PIC16F88X Family Silicon Errata and Data Sheet Clarification

The PIC16F88X family devices that you have received conform functionally to the current Device Data Sheet (DS41291G), except for the anomalies described in this document.

The following typographic corrections and clarifications are to be noted for the latest version of the device data sheet (DS41291G):

FIGURE 1: SCK PULSE VARIATION USING TIMER2/2

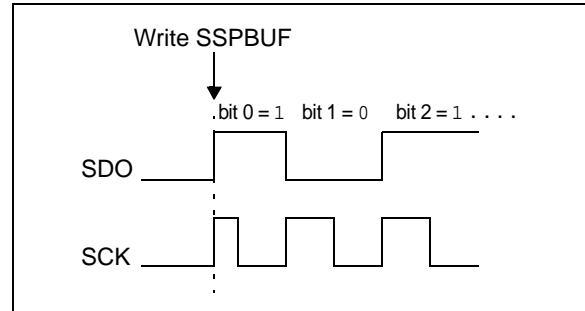
When the SPI is using Timer2/2 as the clock source, a shorter than expected SCK pulse may occur on the first bit of the transmitted/received data (Figure 1).

To avoid producing the short pulse, turn off Timer2 and clear the TMR2 register, load SSPBUF with the data to transmit and then turn Timer2 back on. Refer to Example 1 for sample code.

FIGURE 3: ACTUAL (INCORRECT) OPERATION WITH CLOCK STRETCHING – EXAMPLE 1

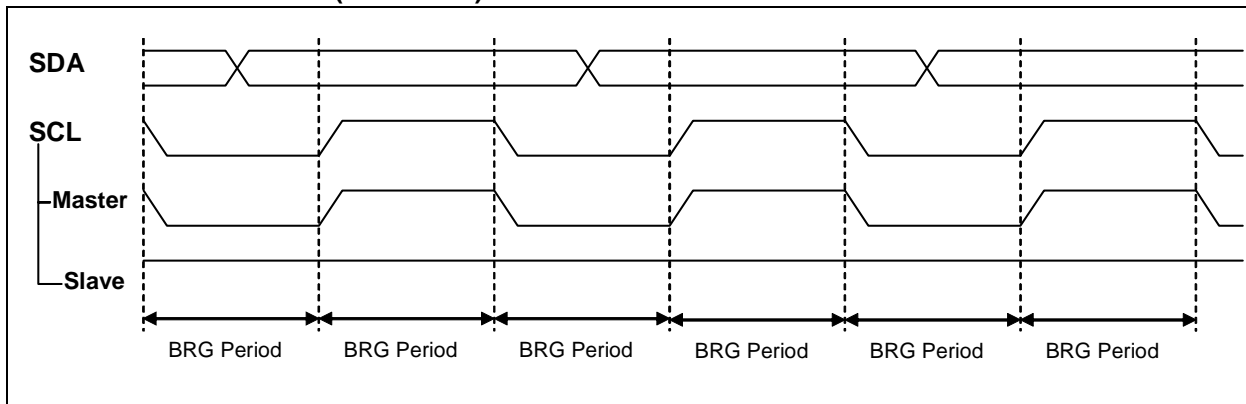
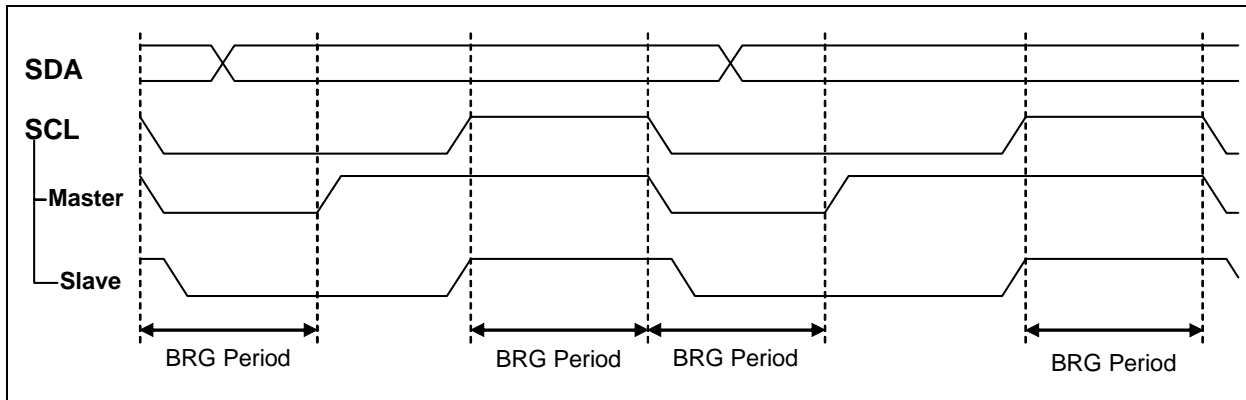
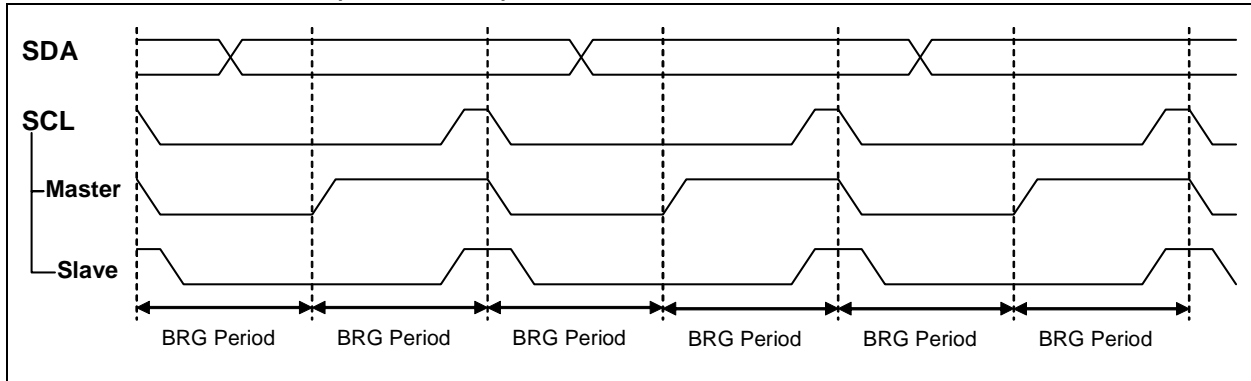
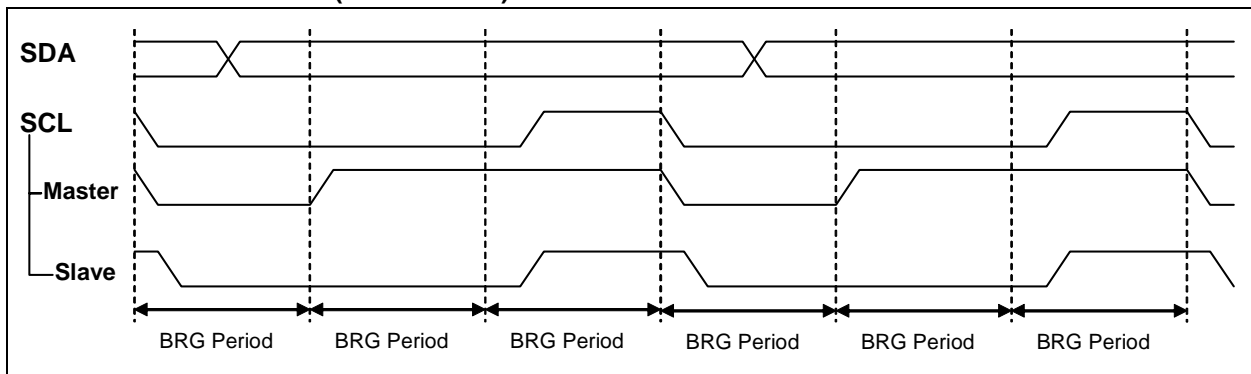
When the MSSP is I²C™ Master mode with a slave device stretching the clock, the clock generation does not function as described in the data sheet.

The current implementation does not ensure accurate SCL high time. During clock stretch, the MSSP device will erroneously continue running the BRG counter. At the end of the clock stretch, the BRG counter continues to count down for the

remainder of the BRG period, and then the MSSP device will immediately resume transmitting the data.

Figure 1 illustrates an expected I²C transmission in which the SCL line is completely controlled by the master device and the slave device does not attempt to stretch the clock period.

Figure 2 illustrates the expected operation of an I²C transmission in which the slave device has stretched the clock period by holding the SCL line low. The high time of the SCL pulse is constant, regardless of the duration of the clock stretch.

Figure 3 and Figure 4 illustrate an actual I²C transmission in which the slave has stretched the clock period by holding the SCL line low. Note that the high time of the SCL signal has shortened from the expected time.

Set the communication speed to match the slowest device on the bus. This ensures that no slave device will perform clock stretching.

It is possible to dynamically adjust the communication speed to match the device being addressed by modifying the BRG register. However, the behavior of slower slave devices must be understood and speed adjustments made such that no slave performs clock stretching.
